# STAGE II CULTURAL HERITAGE IMPACT STATEMENT & CONSERVATION PLAN

145 Loretta Avenue & 951 Gladstone Avenue,  
Ottawa, Ontario

**Revision V5 October 2022**

Figure 18: Standard Bread Building Ground Floor Plan illustrating the layout of the link with the mushroom columns establishing the floor grid. Source: Hobin Architecture 2022.

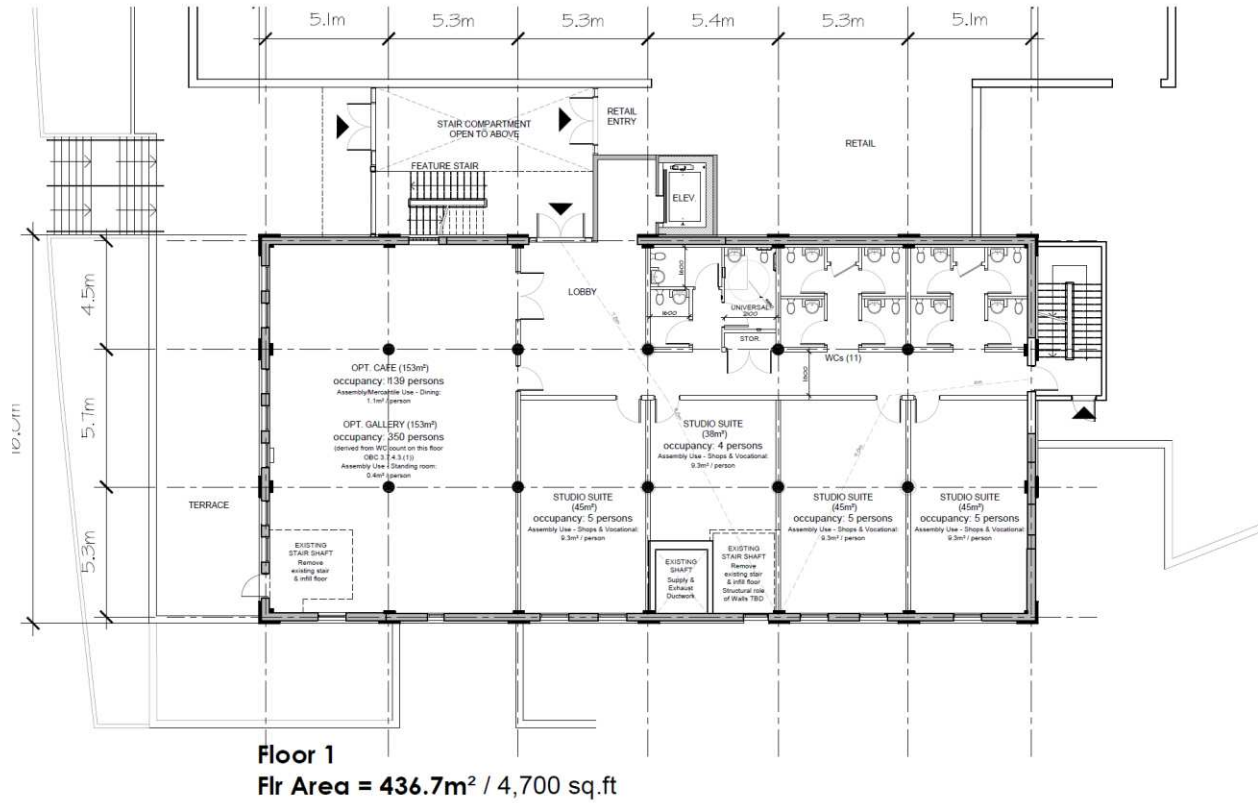
Heritage Staff identified the treatment of the west façade and how the glass link will be attached to the heritage building needing further design development.

**The link between the podium and Standard Bread Building and the north elevation of the link has been setback further to provide a more three-dimensional view of the building when seen from the west. The ground floor expression of the masonry podium at the bay next to the link has been replaced with a more industrial looking metal treatment. The cornice detail of the Standard Bread is a distinct feature that has been picked up as an awning detail over the entrance of the link and as a feature of the ground floor of the awning/podium.**

Figure 33: The 1930 view of the front entrance with a stairway leading from Gladstone and an entrance on the right-hand side of the building are defining features.

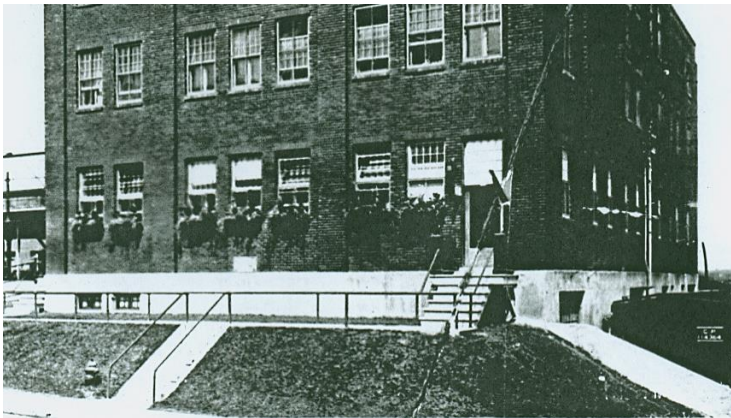
- Staff questions about the following aspects of the proposal, have been addressed as follows:
  - The treatment of the entry/entrance to the designated building as well as any sign board being proposed. **The existing entrance will be maintained as a functional door. The sign board treatment needs further design development as there was no signboard on the building when completed in 1924;** (see the conservation Plan Chapter 7 of this report)

As illustrated **the existing entrance will be maintained as a functional door.** The stairs from the sidewalk leading to the entrance were identified as a character defining feature. Repositioning them aligned with the link helps define the pedestrian flow.

### 7.5.10 The Link

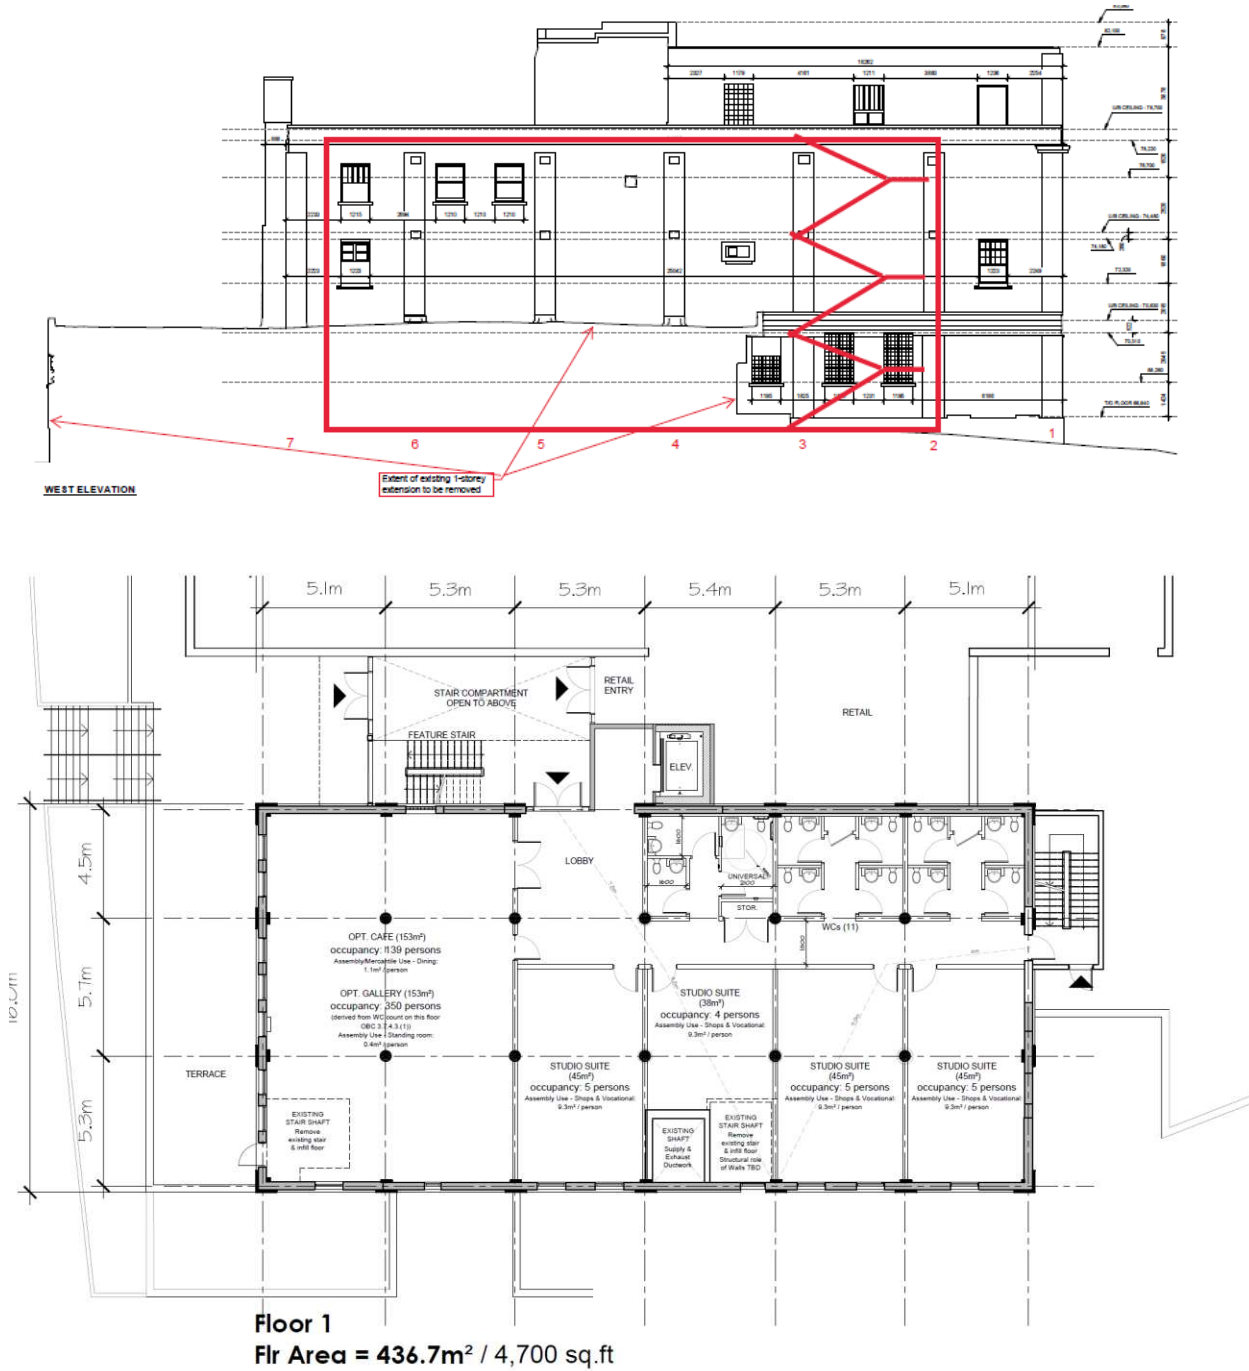
- The treatment of the west façade and how the glass link will be attached to the heritage building. **Needs further design development. The link between the podium and Standard Bread Building has been reduced to three storeys and the north elevation of the link has been setback further**

The link between the podium and Standard Bread Building and the north elevation of the link has been setback further to provide a more three-dimensional view of the building when seen from the west. The ground floor expression of the masonry podium at the bay next to the link has been replaced with a more industrial looking metal treatment. The cornice detail of the Standard Bread is a distinct feature that has been picked up as an awning detail over the entrance of the link and as a feature of the ground floor of the podium.

1. The link (shown in red) will be set back from the front corner of Standard Bread by approximately 5m with its front wall aligned with the second pier. The height will be lower than the factory parapet except for the rooftop access projection shown in the renderings. The exposed brick on the west elevation will be retained as part of the conservation plan.

2. On the west elevation the new stair will be positioned between the 2<sup>nd</sup> and 3<sup>rd</sup> column/pier. Between the third and fourth piers openings will be made to provide access from the link into the Standard Bread Building on each level with the feature stairs providing access to the roof.
